HISTORIC AND DESIGN REVIEW COMMISSION

February 17, 2016

Agenda Item No: 16

HDRC CASE NO: 2016-055
ADDRESS: 220 HERMINE BLVD
LEGAL DESCRIPTION: NCB 9008 BLK 4 LOT 39 THRU 43
ZONING: R4 H
CITY COUNCIL DIST.: 1
DISTRICT: Olmos Park Terrace Historic District
APPLICANT: Stevie Bear/Community REI LLC
OWNER: Austin Hedges/Community REI LLC
TYPE OF WORK: Exterior modifications
REQUEST:

220 W. HERMINE Blvd.
CARPORT ELEVATION DRAWING

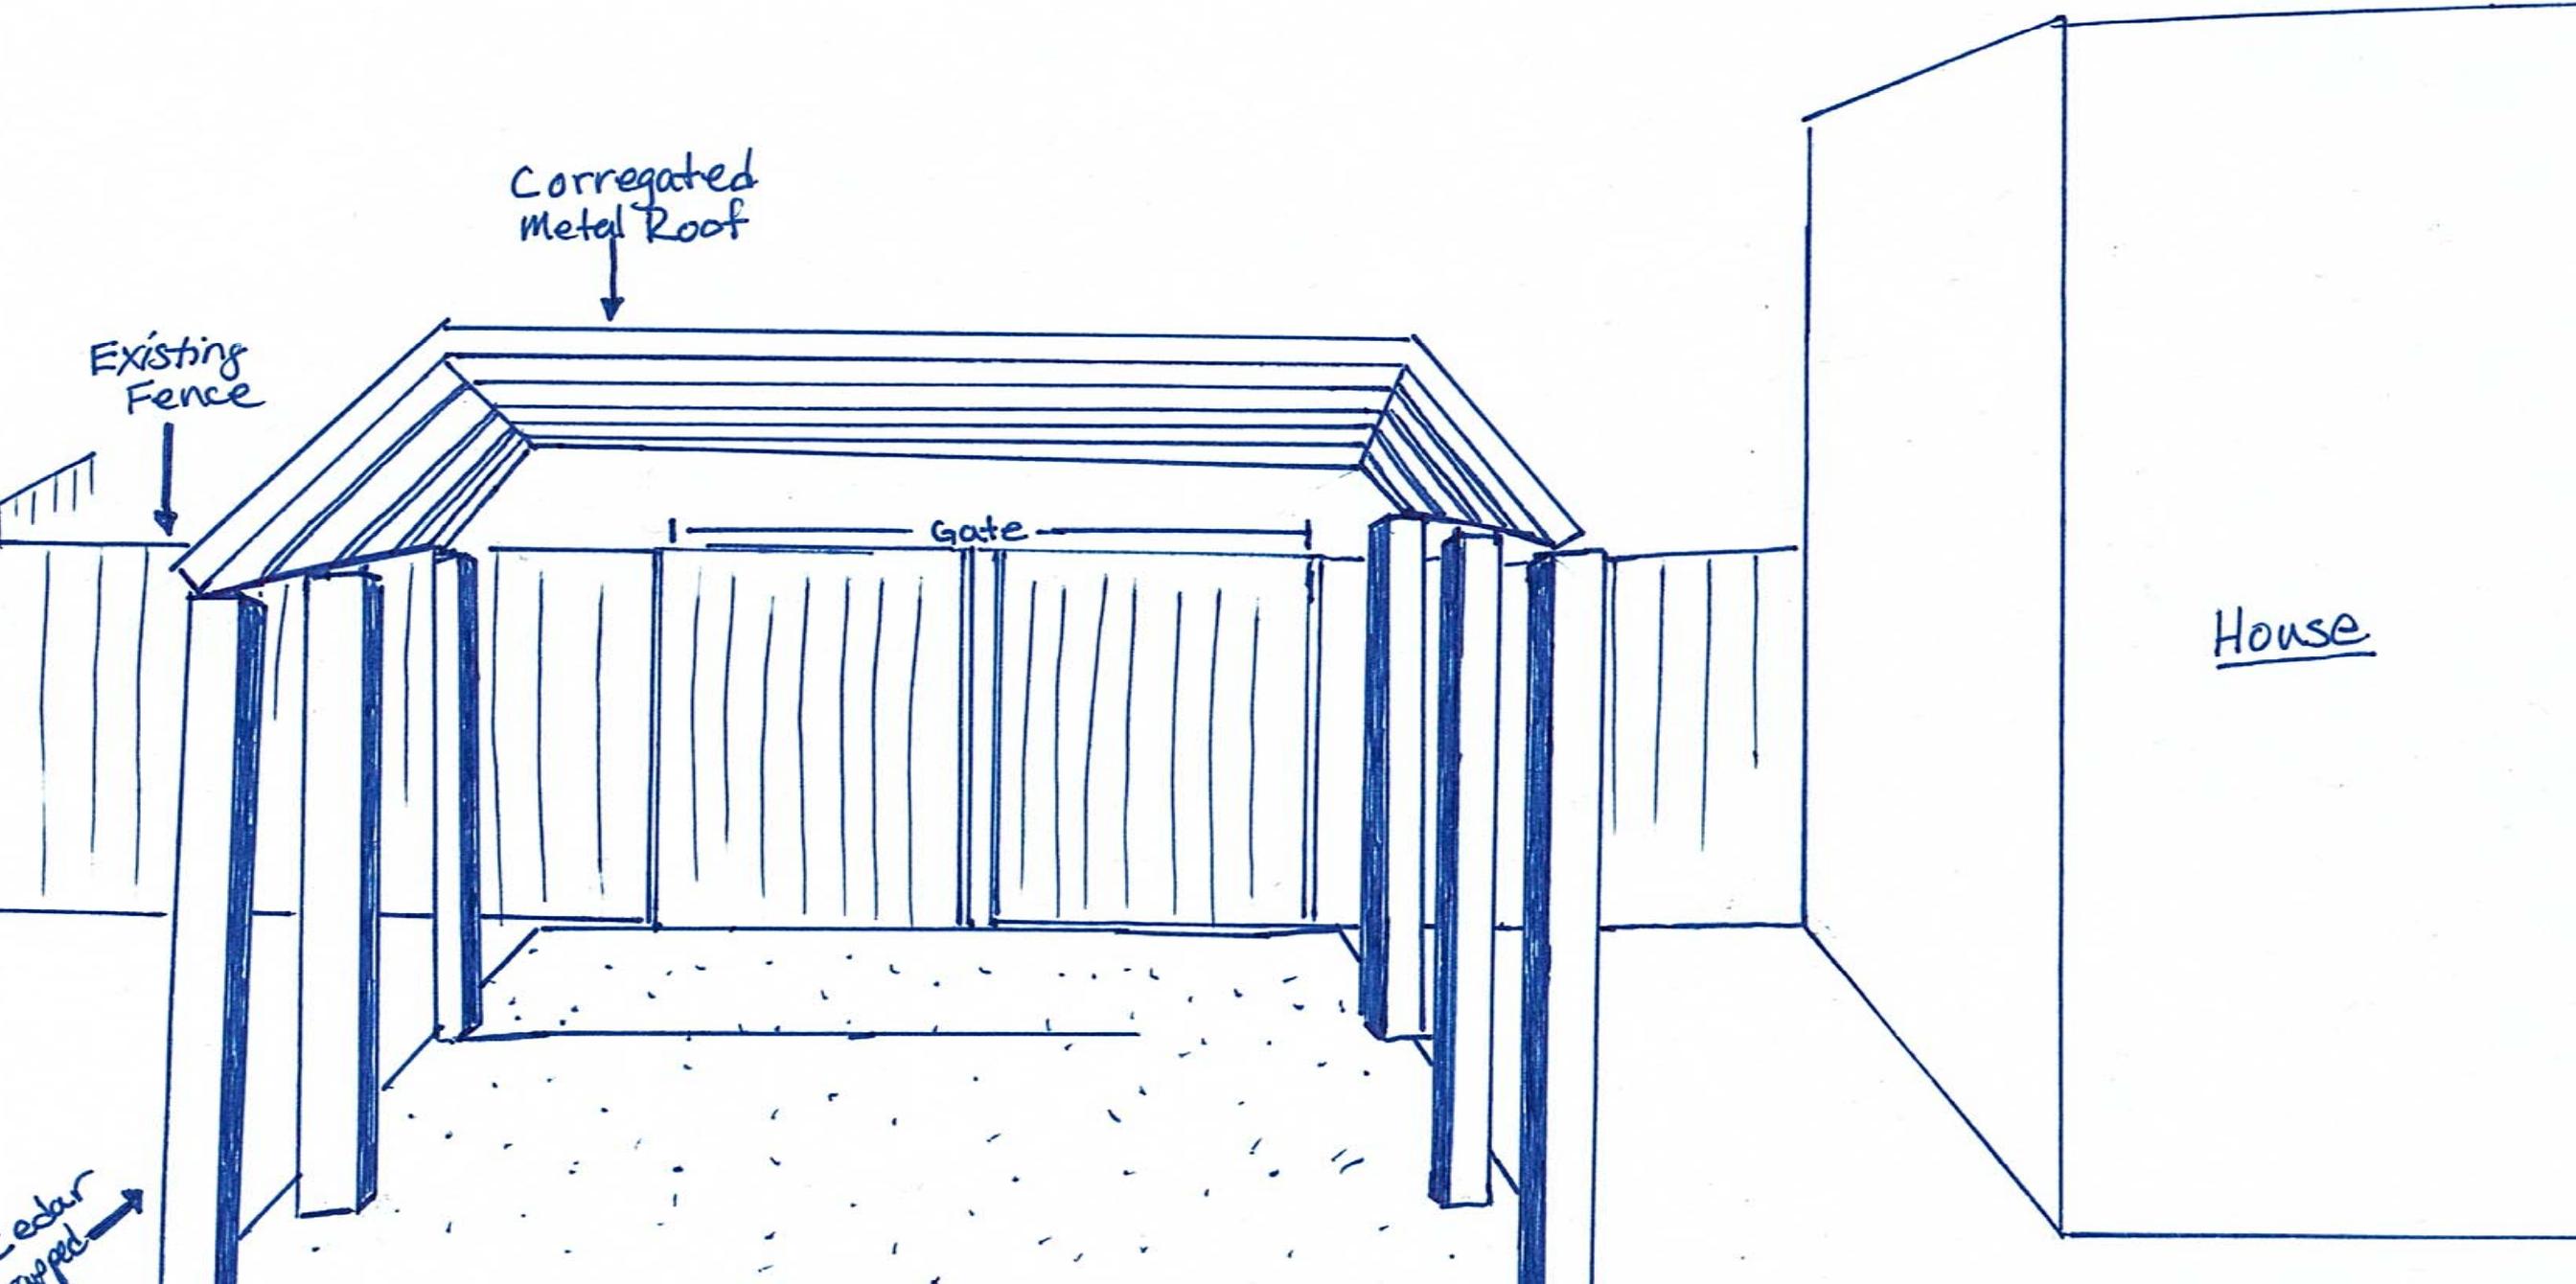
- e. The applicant is proposing to relocate the existing, 19'-8" x 20', non-contributing carport from in front of the garage onto the driveway to side of the east façade as well as wrap the posts in cedar to create square posts. According to the Guidelines for New Construction 5.A.iii., new outbuildings should relate to the period of construction to the main structure. Staff finds this placement appropriate. Staff made a site visit February 8, 2016, and found that carports are prominent on the street; however staff finds that a prefabricated carport structure is not appropriate for the historic structure's architecture style or the district. The applicant's proposal to locate the prefabricated carport structure to the side of the primary historic structure is not appropriate.

Staff recommends approval for items #1 and #2 based on findings b and c with the stipulation that the applicant provide specifications for the two fixtures and rear door prior to receiving a Certificate of Appropriateness. Staff does not recommend approval of items #3 through #7 based on findings d through i. Staff recommends the applicant propose a front door that is architecturally appropriate as noted in finding g, propose a garage door with minimal detailing and ornamentation as noted in finding e and repair existing light fixtures and windows as noted in findings h and i.

Covered Back Deck Sketch

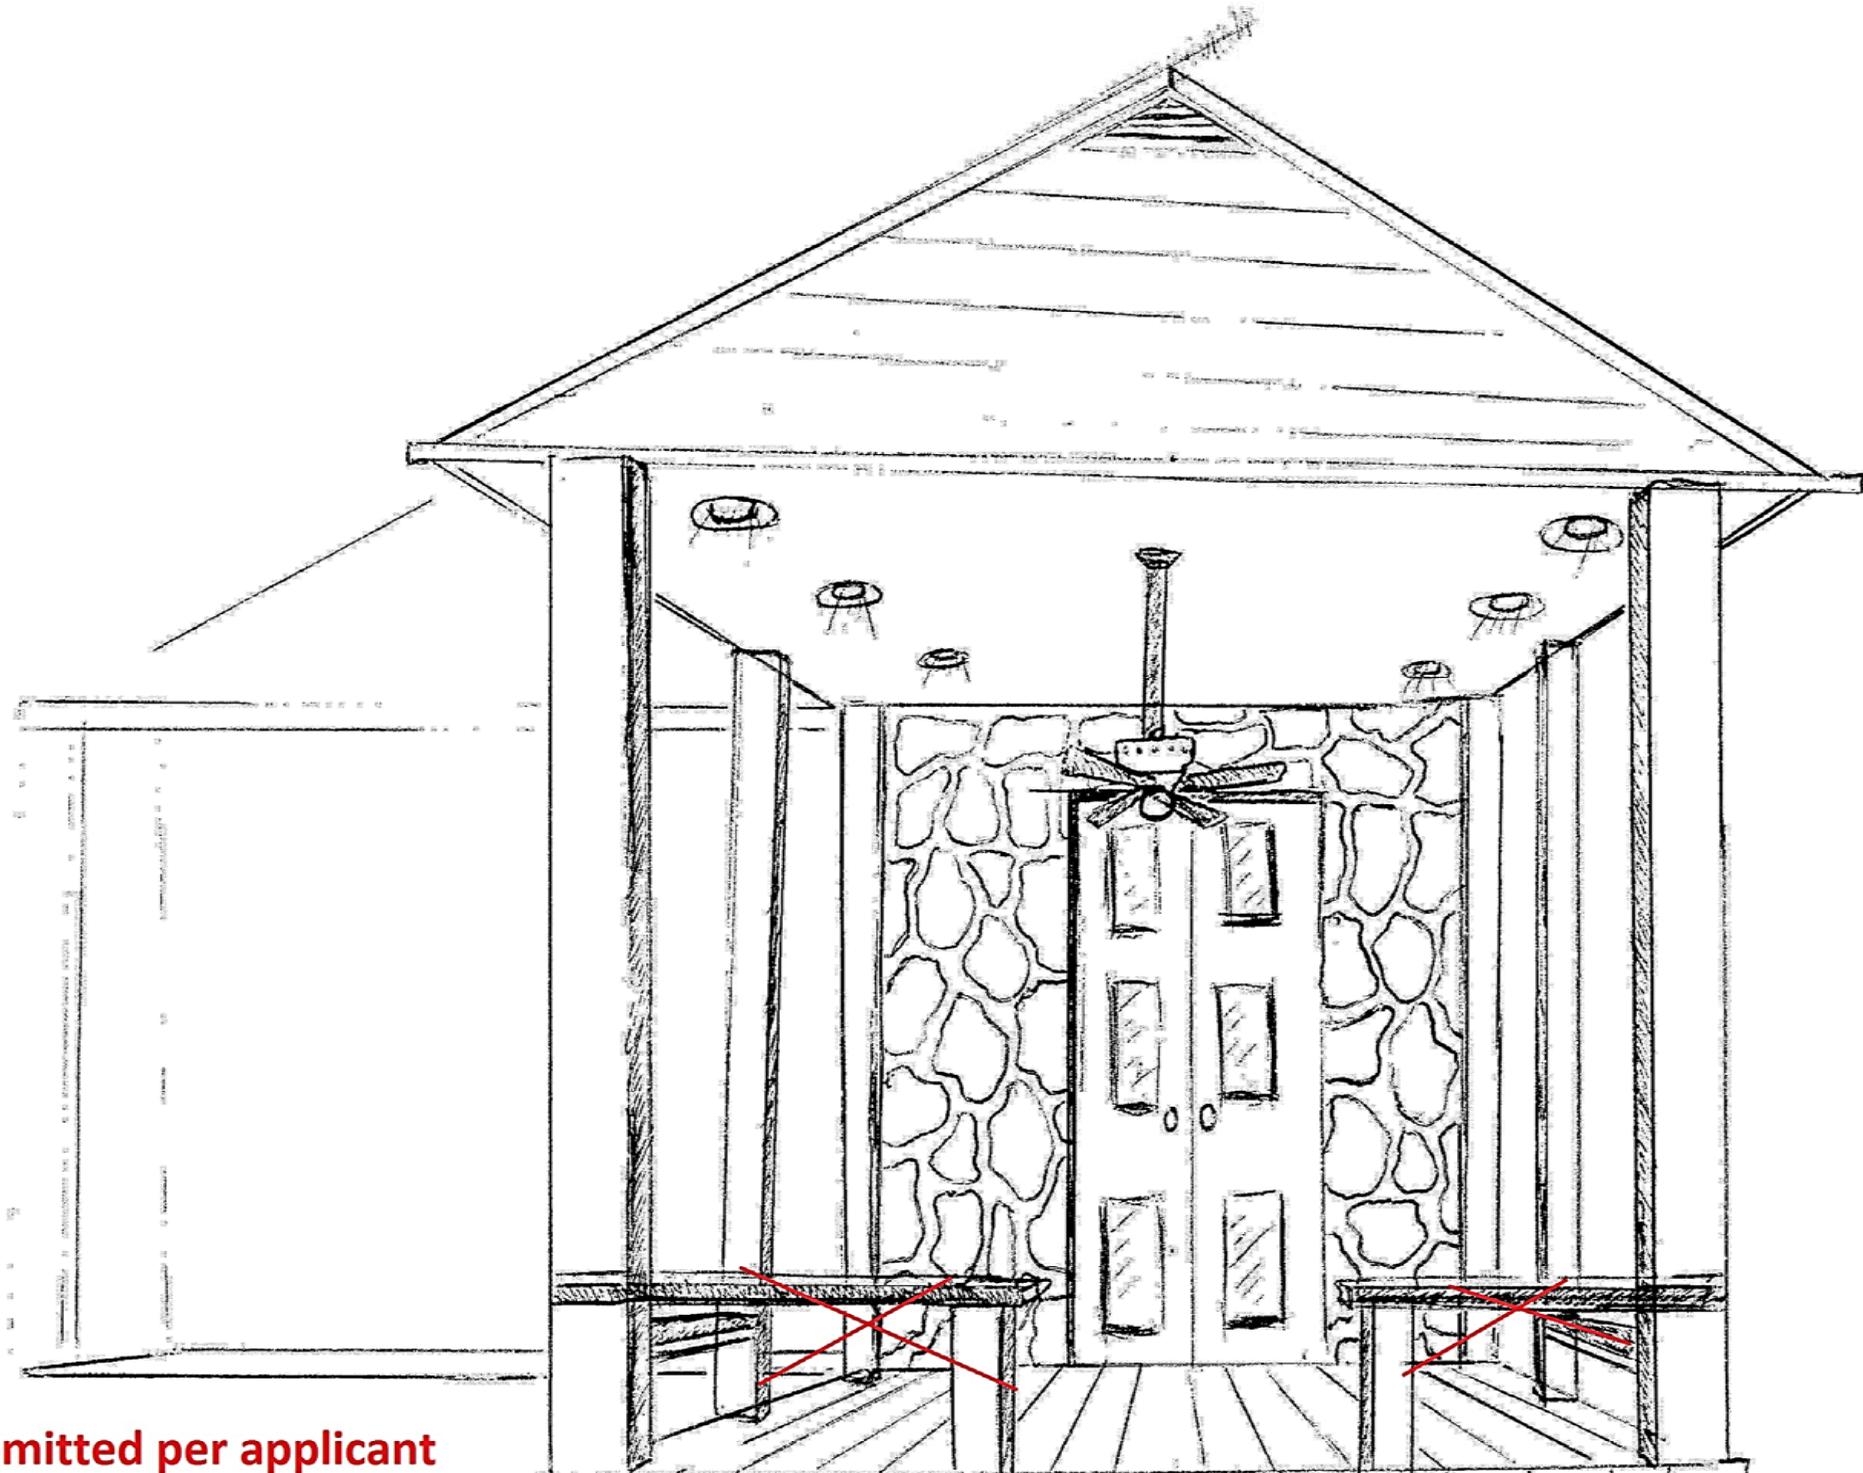
- c. At the rear of the primary historic structure, the applicant has proposed to demolish three walls of the rear of the house, and repurpose as a 20'-3" x 20'-4" covered deck, with lumber decking, 6 new lumber posts, 6 recessed lights in existing ceiling, and two ceiling fans. The applicant area to be exposed is an addition as there are masonry walls enclosed in the interior.

- d. The applicant has proposed to install a sliding glass door. Staff recommends that the applicant provide product specifications regarding this door.
